Product Change Notification / BLAS-29UKEN164

CCB 6507 Final Notice: Qualification of HANA as an additional assembly site for selected MCP1792 and MCP1799 device families available in 3L SOT-223 package.

Pre and Post Change Summary

PCN# BLAS-29UKEN164

LPI

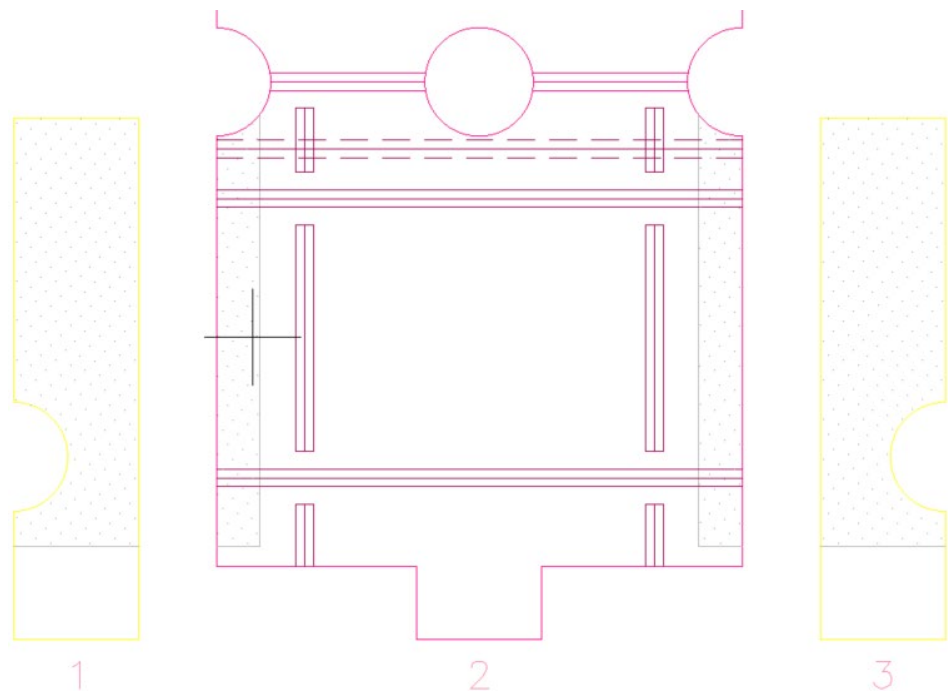
Lead-Frame Material	PMC
Lead-Frame Paddle Size	118x97mils

HANA

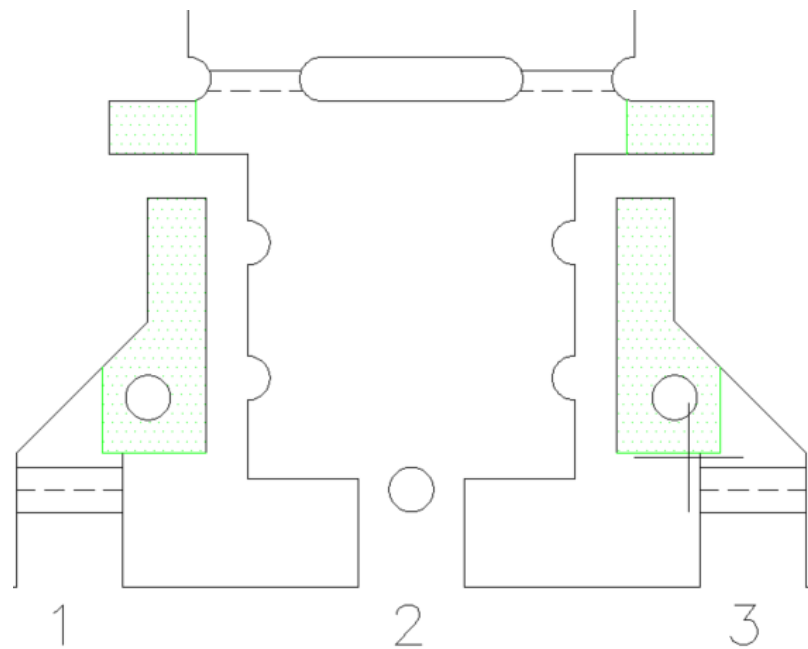
Lead-Frame Material	C194
Lead-Frame Paddle Size	100x87mils
